Agenda City of Placerville Planning Commission

5.1 3001 JACQUIER ROAD – SITE PLAN REVIEW 16-02 & VARIANCE 16-01

City of Placerville Planning Commission **STAFF REPORT**

APPLICATION NO.:	Site Plan Review 16-02 & Variance 16-01
DATE:	January 17, 2017
REQUEST:	Site Plan Review Approval for a 112 room hotel (Hampton Inn and Suites) and Variance request for building height.
STAFF:	Pierre Rivas, Director
APPLICANT/OWNER:	All Four One, LLC
AGENT:	Brad Whitaker, Wasach Growth Partners – GHD, Inc. (Blake Johnson).
LOCATION:	3001 Jacquier Rd, northeast corner of Point View Drive and Highway 50, APN: 048:290:42
GENERAL PLAN:	Highway Commercial designation
ZONING:	Highway Commercial – Airport Overlay (HWC - AO)
PARCEL AREA:	3.01 acres
CURRENT USE:	Vacant – suspended construction on a 102-117 room hotel (Holiday Inn Express).
SURROUNDING USES:	North – Rural Residential; West – Single & Multi-Family Residential; South – Highway 50; East – Mixed Residential & Commercial (Smith Flat)
REQUIRED SETBACKS:	None
RECOMMENDATION:	Adopt findings and approve Site Plan Review 16-02 for a 112 room hotel (Hampton Inn and Suites); and adopt findings and approve Variance 16-01 for building height allowing fo

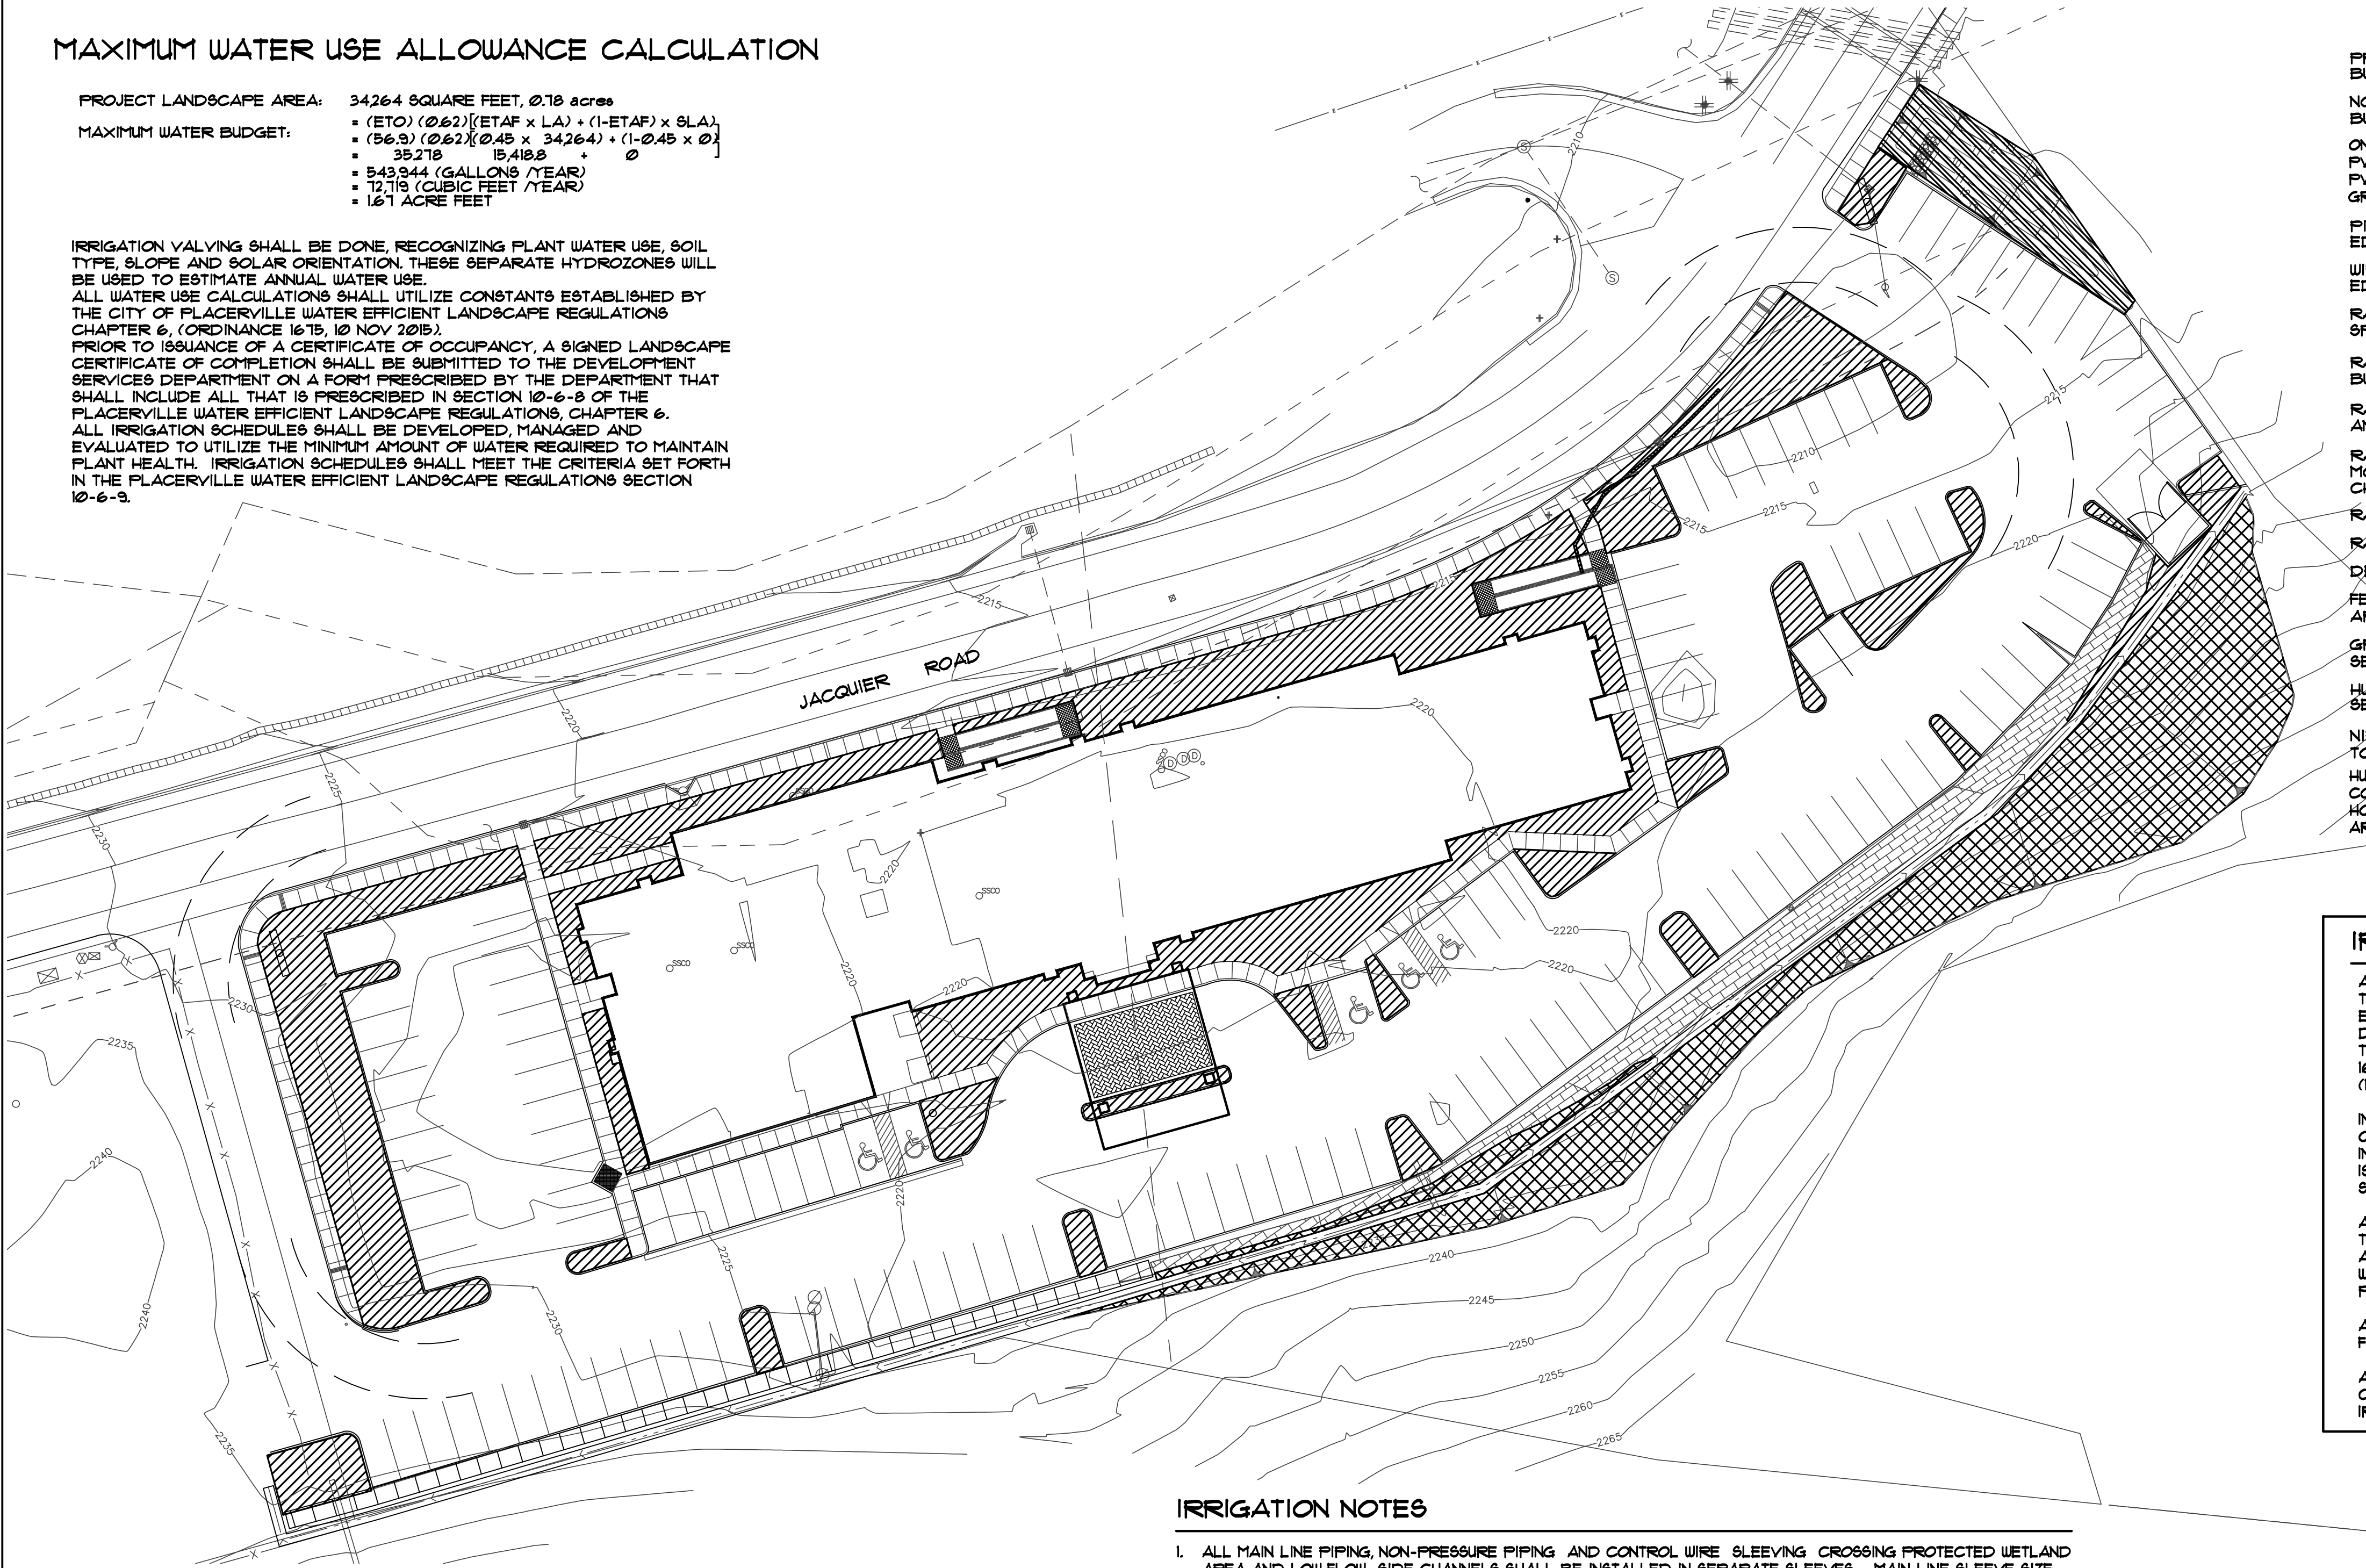
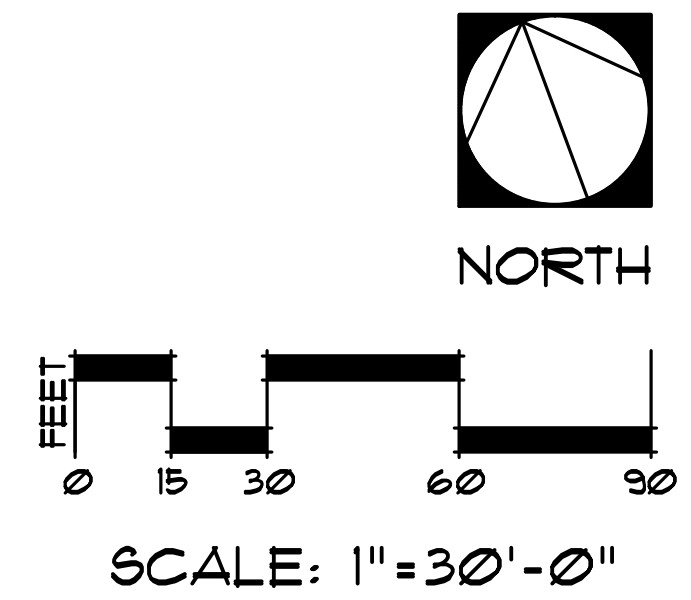
There are areas where the Preliminary Landscape Plan is deficient in detail that must be addressed in a Final Plan submittal. First, there are several areas in the parking area that do not meet the threshold for planters at 10 stall intervals. Secondly, the location of ground-mounted electromechanical equipment that supports ground floor services is not shown on the plan. Most of the equipment will be placed in the western half of the hotel given the floor plan. A reconnaissance of the Folsom hotel confirmed this issue. A Condition of Approval addresses this issue that requires a combination of physical and landscape screening subject to approval by staff.

- ii. The Landscape/Site plan shall be modified to include two additional parking lot landscaping strips as discussed herein subject to review and approval by staff.

Project No:15002
Date: 7-1-16
Drawn: -
Checked: ----
Drawing Title:
SITE PHOTOMETRIC
PLAN

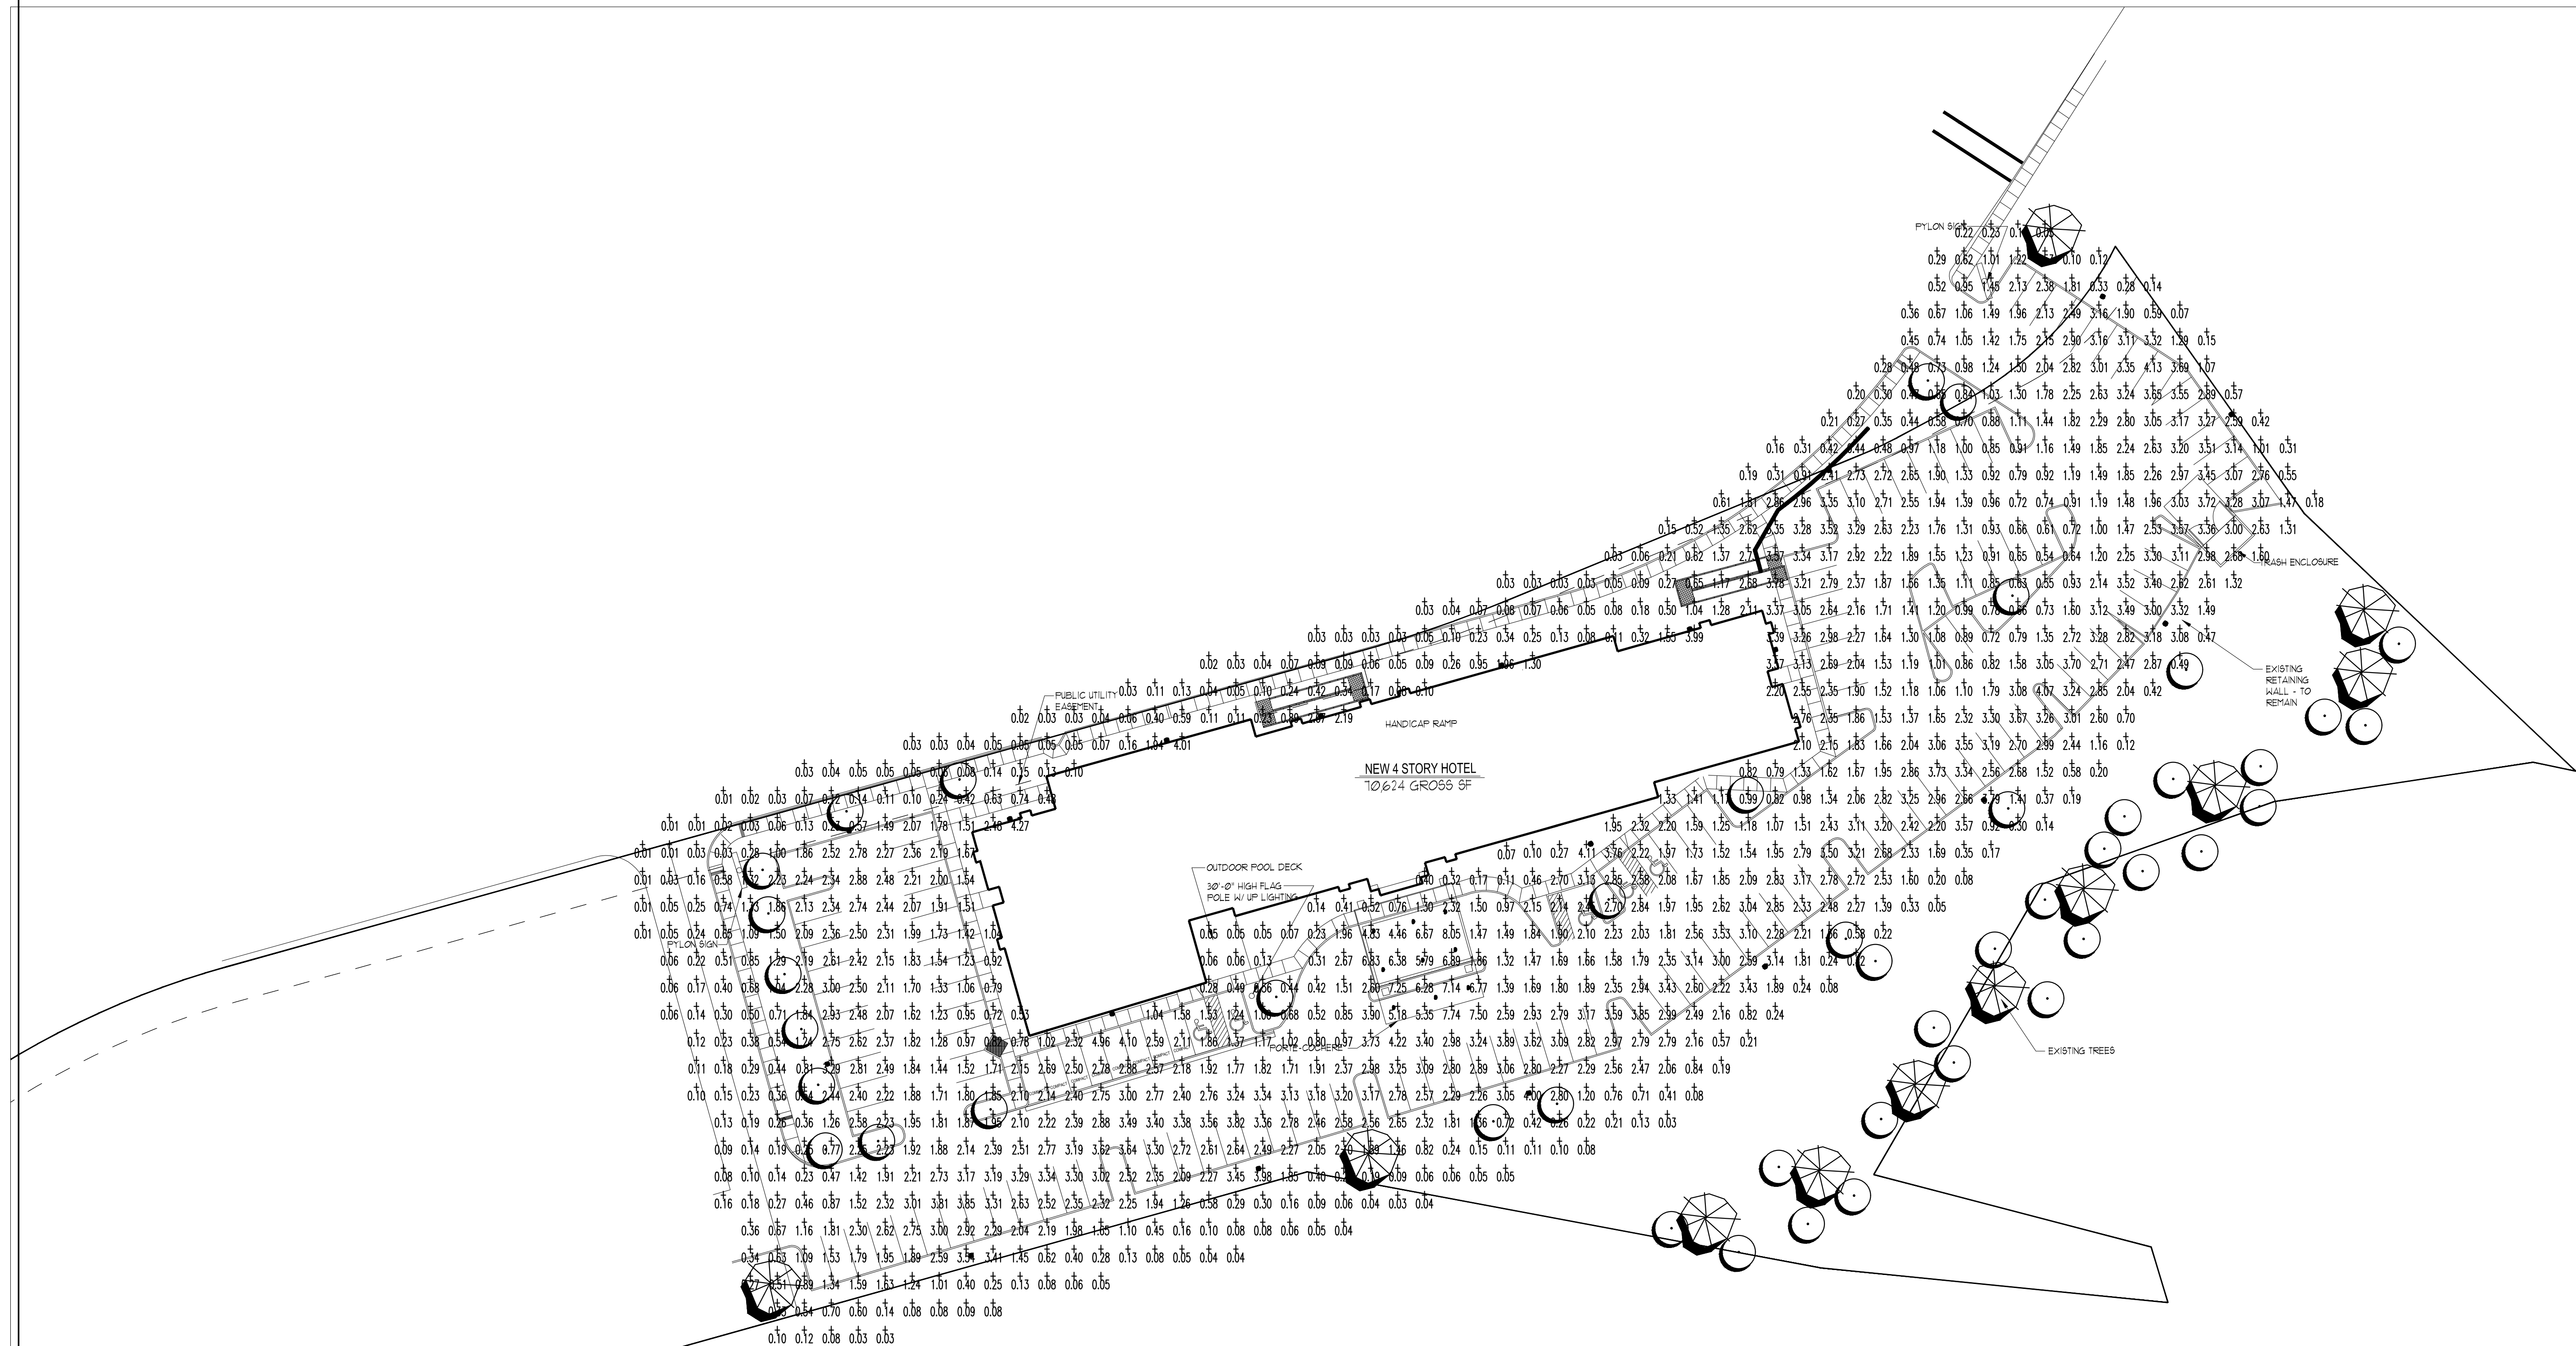
Exterior lighting for the hotel site generally consists of three types of lighting which includes: under-canopy lighting; wall mounted fixture (wal-pak) on the north (street) elevation, and 25' tall parking lot fixtures. The specifications of each fixture are shown on Sheet E002. Staff has reviewed the exterior lighting plan and accompanying photometric analysis and concludes that the proposed exterior lighting complies with the prescriptive criteria set forth in code in terms of complying with meeting light trespass at property lines, meeting minimum lighting levels for walkways and parking area, and pole light height standards. Staff notes that the "wal-pak" lighting on the north elevation is architecturally inappropriate and should be substituted with the decorative fixture show on sheet E002 as Option 2. A condition of approval to this issue is incorporated herein.

- vi. The proposed “wall-pack” light fixtures as shown in the lighting plan are not permitted. Applicant shall submit alternative light fixtures to the Planning Division for staff review and approval.
